FLORIDA POWER & LIGHT COMPANY

TURKEY POINT UNITS 3 AND 4

**EMERGENCY POWER SYSTEM
ENHANCEMENT PROJECT
RESPONSE TO NRC'S REQUEST
FOR ADDITIONAL INFORMATION
(RAI'S)
REVISION 1**

MAY 1990

FIGURE 1-1
 EPS ENHANCEMENT PROJECT
 CIVIL/STRUCTURAL CRITERIA
 (NOT TO SCALE)

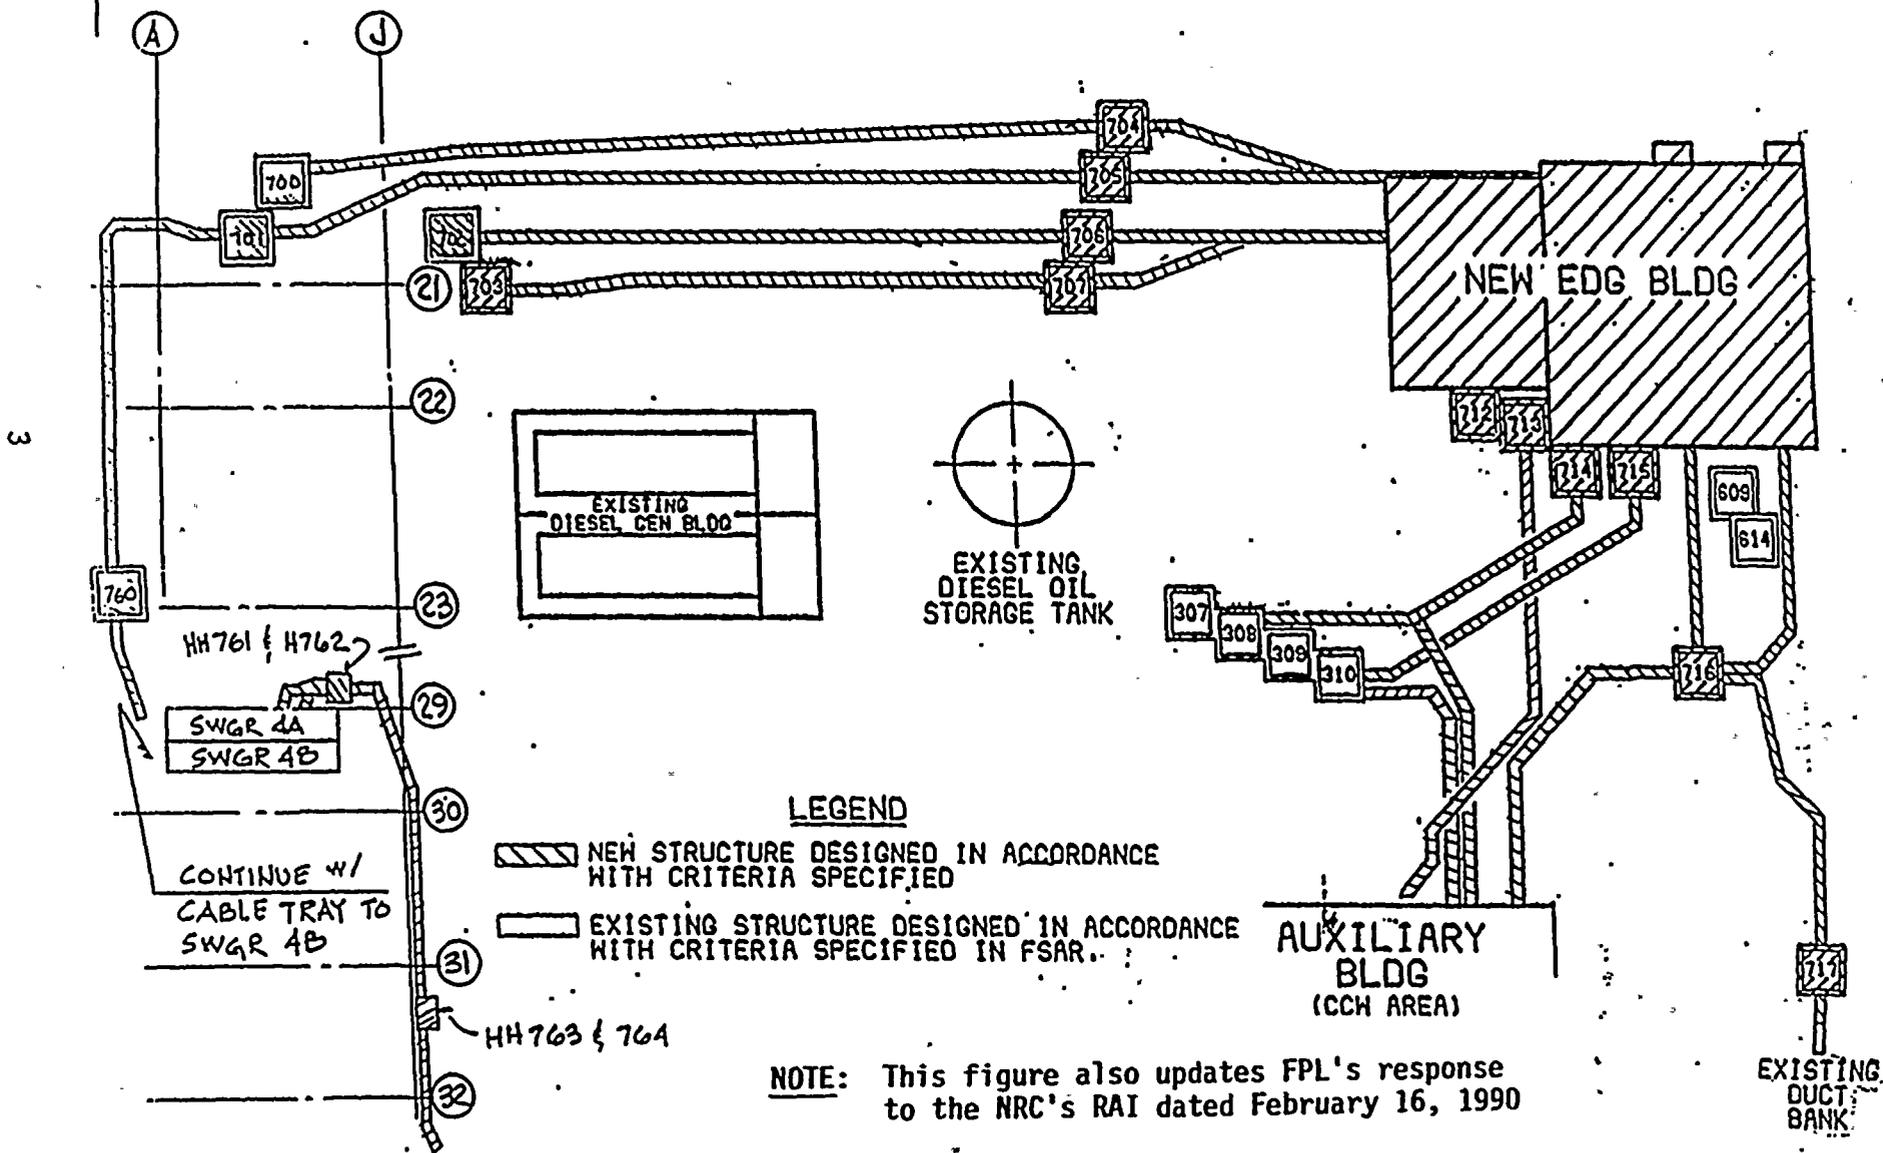
Identify the applicable Codes, Standards, Regulatory Guides, NUREGs, General Design Criteria, Generic Letters, and other documentation (hereafter "Standards") that are to be applied to the system enhancement. For each Standard identified, indicate to which part or parts of the system enhancement that the Standard will apply.

The new EDG building, all internal structures, and all new exterior structures (i.e., ductbanks and manholes) as shown on Figure 1-1 will be designed in accordance with the following criteria. Modifications and additions to existing structures will be designed in accordance with the criteria specified in the FSAR.

Missile protection will be provided for the new EDG building and new exterior ductbanks and manholes shown on Figure 1-1. Missile barriers will be designed to resist penetration and impactive dynamic loading in accordance with the criteria provided in SRP 3.5.3. The following missiles will be considered in barrier design.

FIGURE 32-1
 COOLING SYSTEM HEAT TRANSFER CAPABILITY
 (AT 110% RATED LOAD)

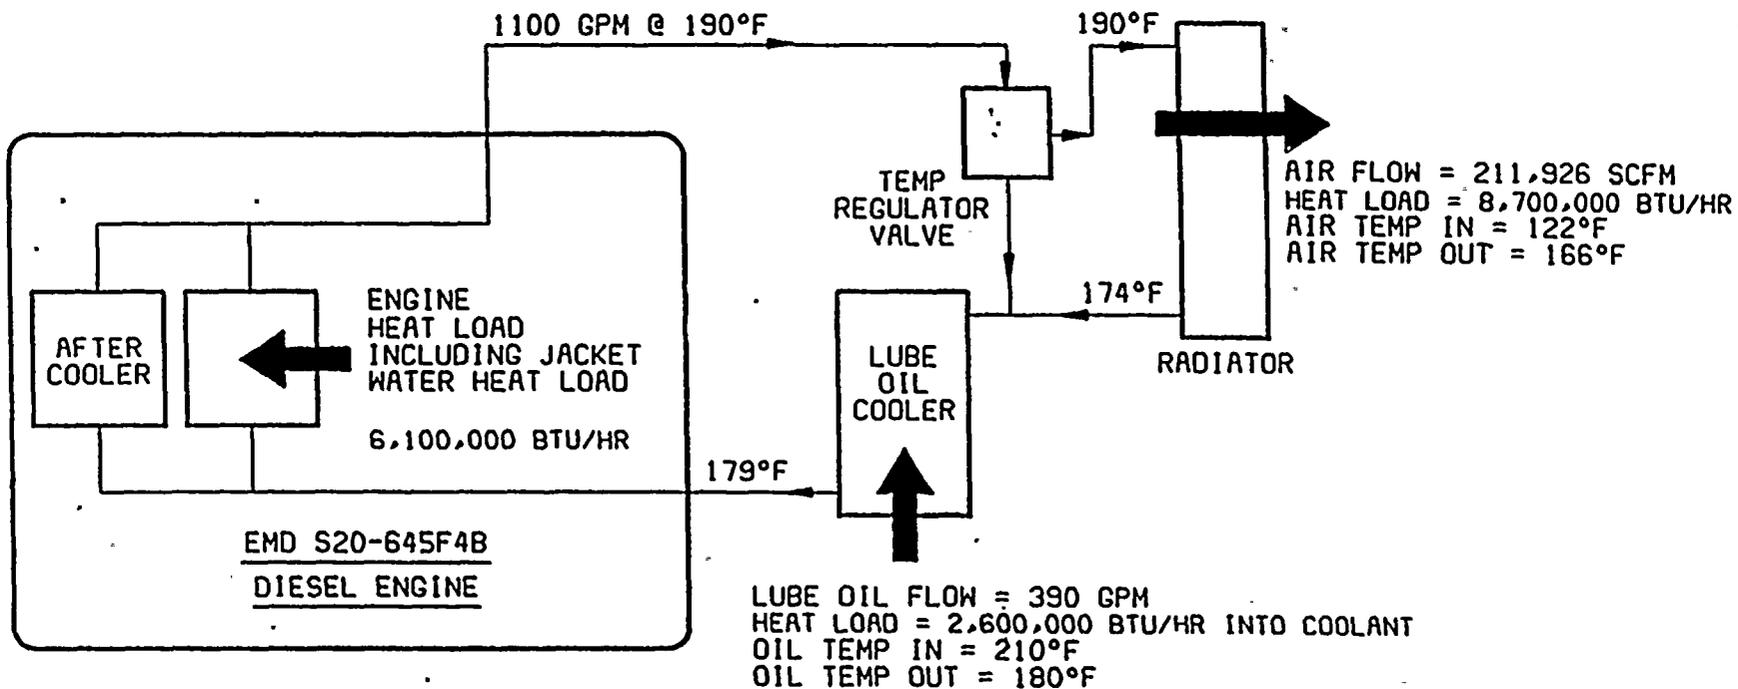
Provide a tabulation showing the individual and total heat removal rates for each major component and subsystem of the diesel generator cooling water system. Discuss the design margin (excess heat removal capability) included in the design of major components and subsystems.

The attached Figure 32-1 identifies the total and individual heat removal rates for the diesel generator cooling water system at 110 percent rated load. The cooling system is designed to maintain a top tank (water leaving the engine) temperature of 190°F at 110 percent rated load and radiator cooling air entering the radiator coils at 122°F. Since the engine is typically not operated at 110 percent rated load, the actual heat removal requirements are lower. The lower actual heat load constitutes design margin for the system.
